## Staff Report to the Zoning Administrator

Application Number: **08-0223**

**Project Description:** Proposal to construct a two story single family residence (about 3,721 square feet) with associated site improvements (including a shared roadway, with retaining walls up to 4.5 feet above and 8 feet below the roadway) and to remove three significant trees on a vacant property.

## COLOR & MATERIALS

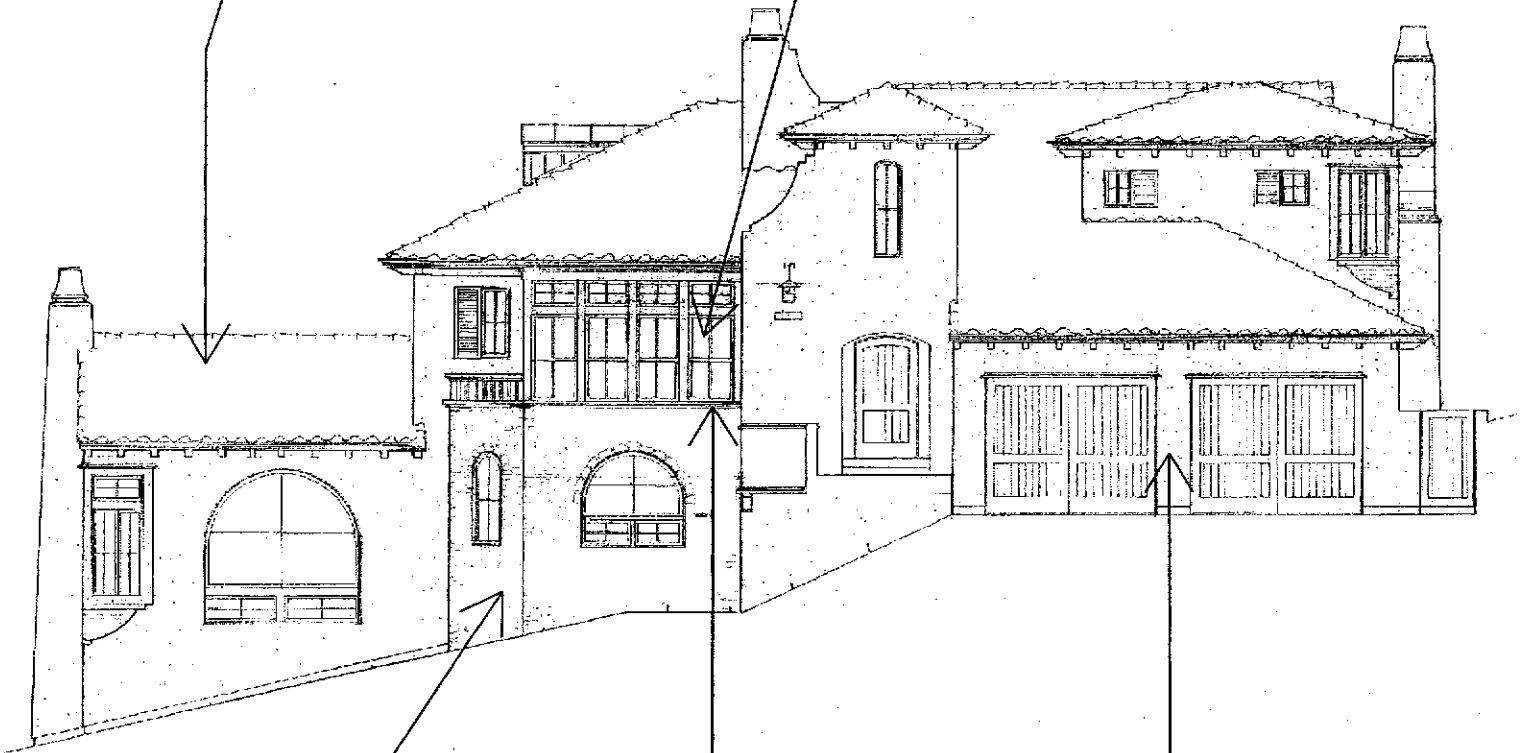
- a. The body color for the residence on Lot 2 shall be modified to be a light brown or tan color. The color selection shall be balanced with the colors of the other residences to provide variety and to allow the structure to recede into the background.
